January 27, 2025

AOA-6656

**SUBJECT: Stream Buffer Reduction and Enhancement for Forest Creek Lot 1
5222 Forest Ave SE, Parcel 141030-0057, Mercer Island, WA
Revised (City File # CAO24-032)**

FIGURE 2: SITE PLAN
SEASCAPE HOMES
FOREST AVE - BUFFER MITIGATION PLAN
MERCER ISLAND, WASHINGTON
PARCEL 1410300057

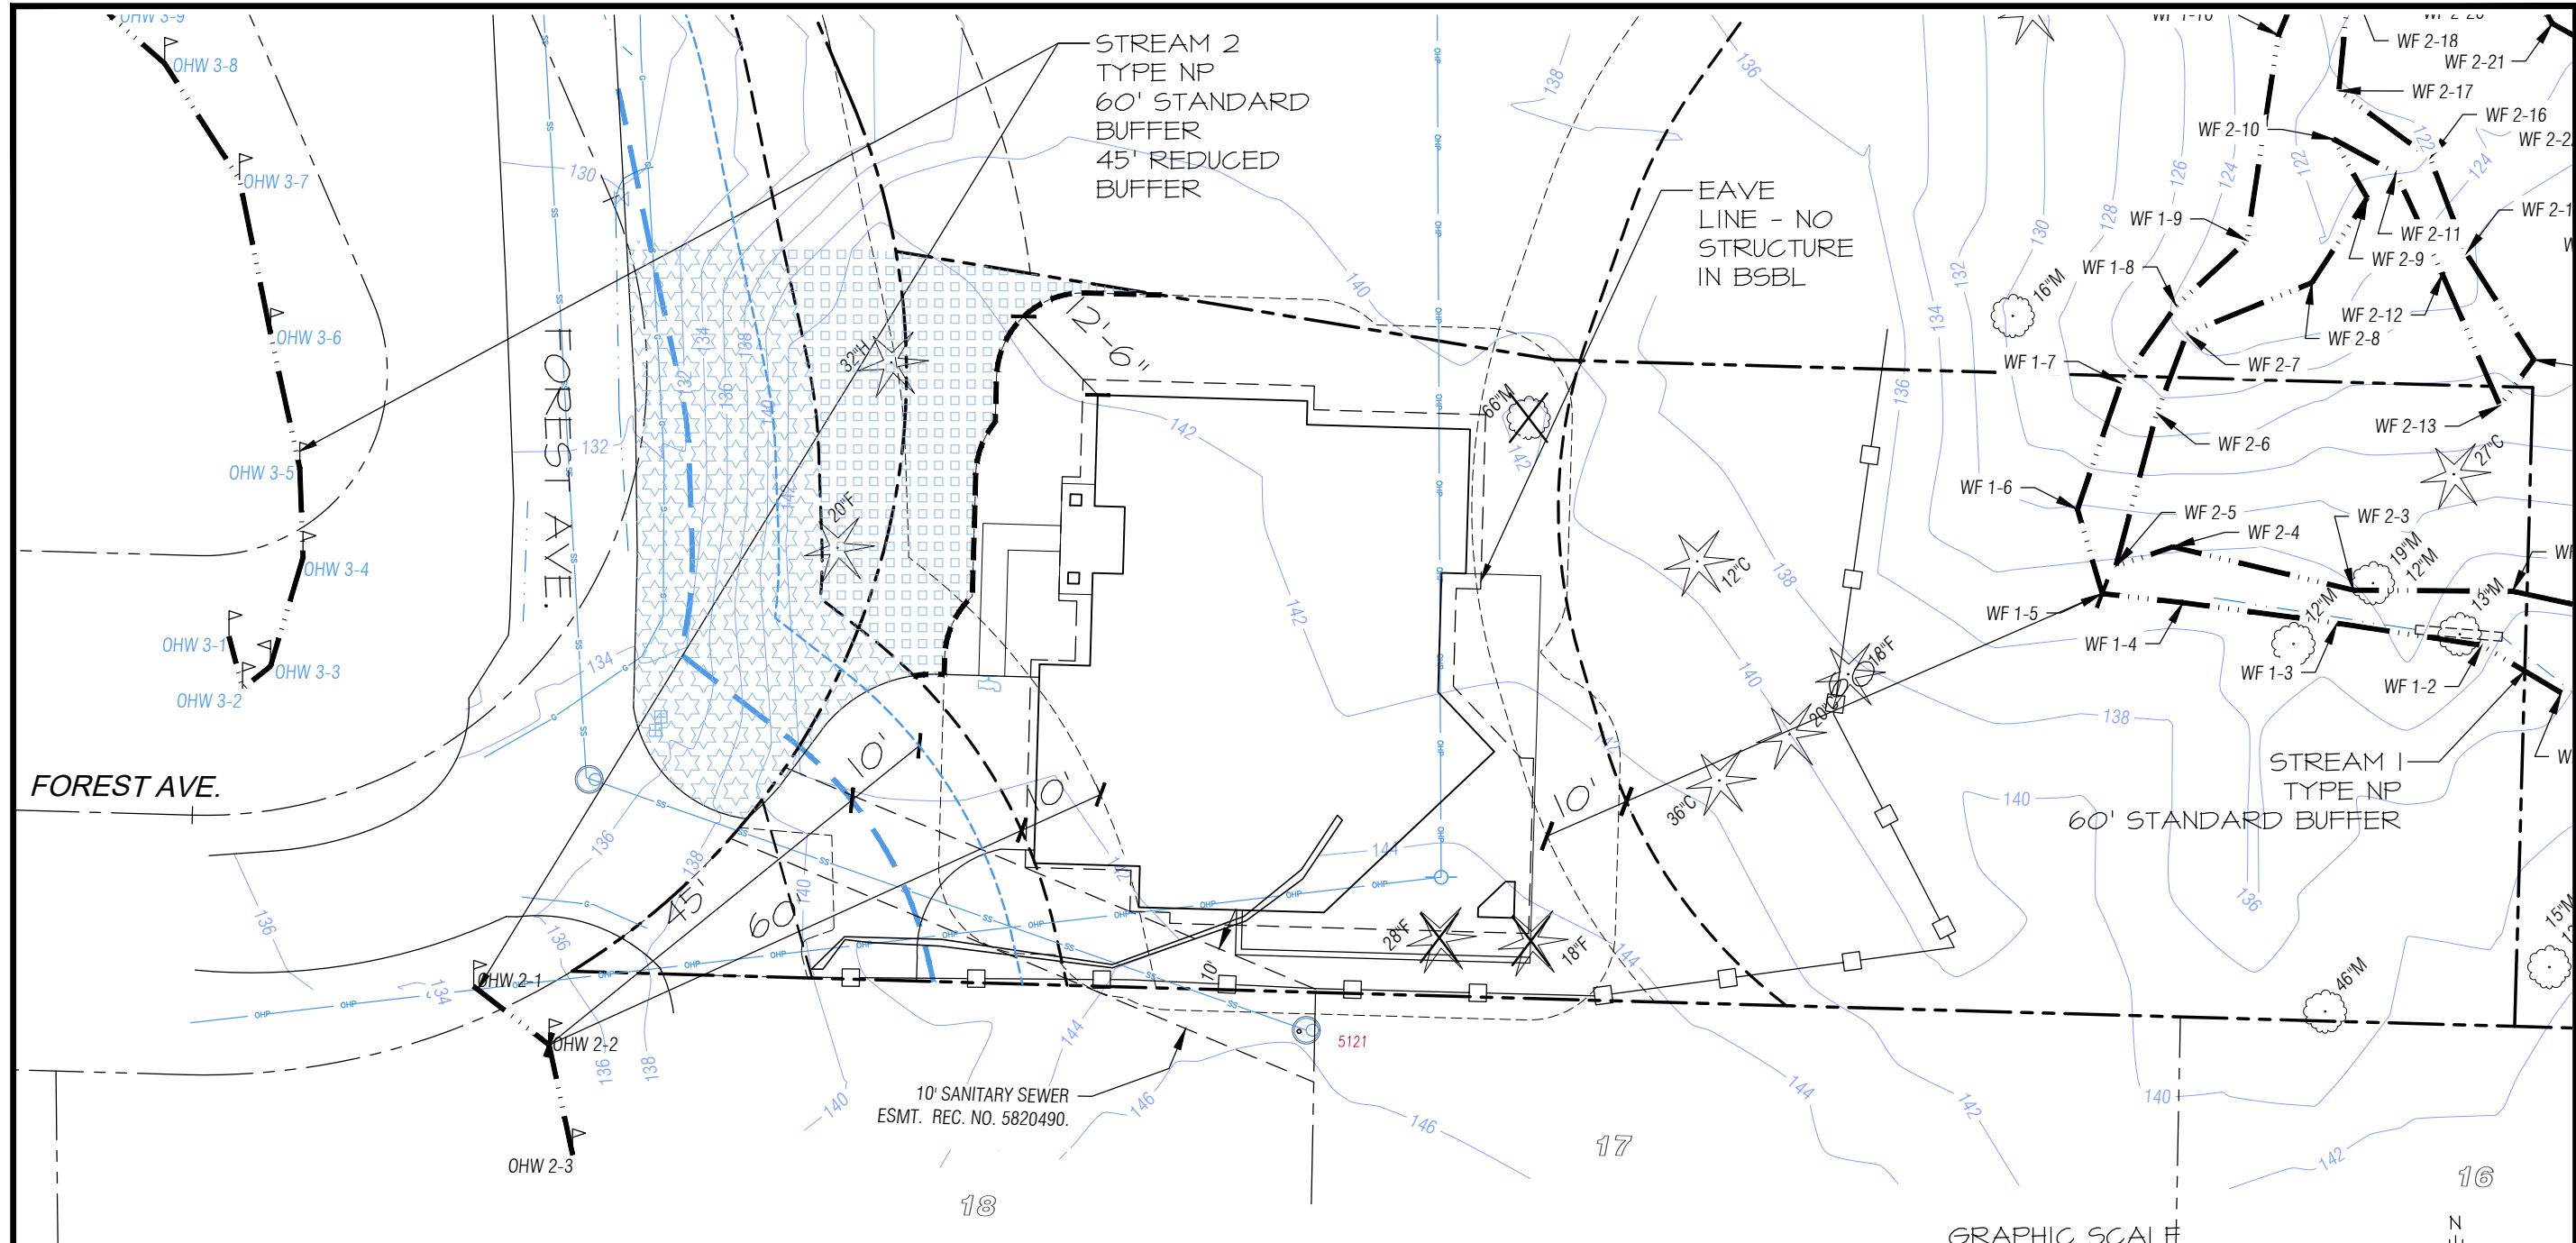
We have updated this report and attached plan set per the comments presented in the January 7, 2025 review letter from the City of Mercer Island. Revisions requested included: 1) removal of reduced buffer from Stream 1 on Figure 2 of plan set, 2) clarification that no intrusion into the building setback of Stream 1 with any structure will occur, 3) clarify text in report that no buffer reduction from Stream 1 is proposed, and 4) removal of tree plantings within Forest Ave. right-of-way (only shrubs will be planted in right-of-way).

The standard 60-foot watercourse buffer from Stream 2 currently extends into the southwest portion of the site and the required location of the proposed residence. A reduced buffer is proposed for Stream 2. No buffer reduction is proposed for Stream 1
